Access Compliance Report

Public Rights-of-Way

(Curb Ramps)

Intersection ID: 27044	Main Street: GOVERNORS_RW	Cross Street: HURSTBOURNE_GREEN_DR	Location: SE
ADA ID: 6C92440310AF	Ramp Type: Directional1	Initial Pass/Fail: Fail	Overall Compliance: No
Severity Score: 8.75			
Codes/Mitigation Info/Possible Solution		Field Measurements/Component Compliance

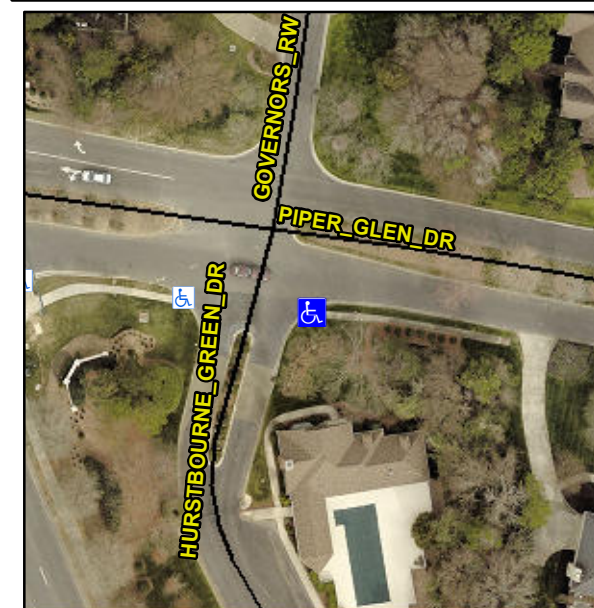
R304.5.1

Remove & Replace Entire Ramp.
